## SERVICE BULLETIN

**APPLICABILITY:** 2010-**19MY** Legacy and Outback  
 2014-**19MY** Forester  
**2012-19MY** Impreza  
**2013-19MY** Crosstrek (Exc. 19MY PHEV)  
 2015-**19MY** WRX  
**2019-20MY** Ascent

**NUMBER:** **16-103-16R**

**SUBJECT:** Transmission Fluid Seepage

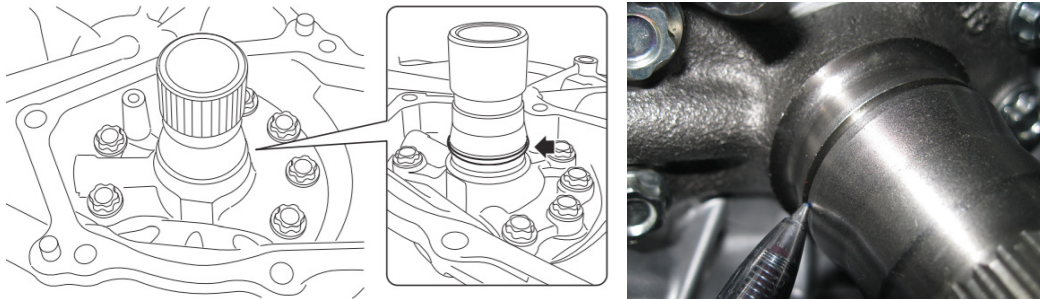
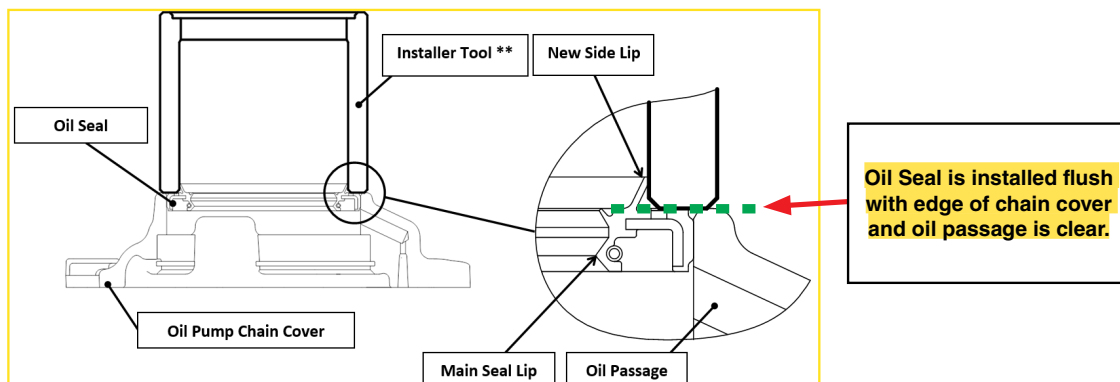
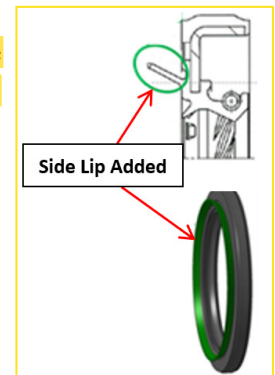
- The re-designed input shaft oil seal has a new side lip added to supplement the existing main seal lip. The purpose of the additional side lip is to direct the flow of dust and water around the seal and away from the sealing surfaces.
- Apply CVT fluid to the main seal lip **only** before installation.
- When installing this new seal, it is **STRONGLY** recommended to use the proper installer tool **\*\*OPTIONAL Special Tool 927890000** as shown in the illustration below. Otherwise, If the seal were to be installed too deep into the bore of the chain cover (beyond flush with the chain cover edge as shown below), the oil passage may become restricted or blocked.

**NOTE:** Should the cover need to be replaced, always confirm the new part has the new-style input shaft seal with the additional side lip as described below before installation.
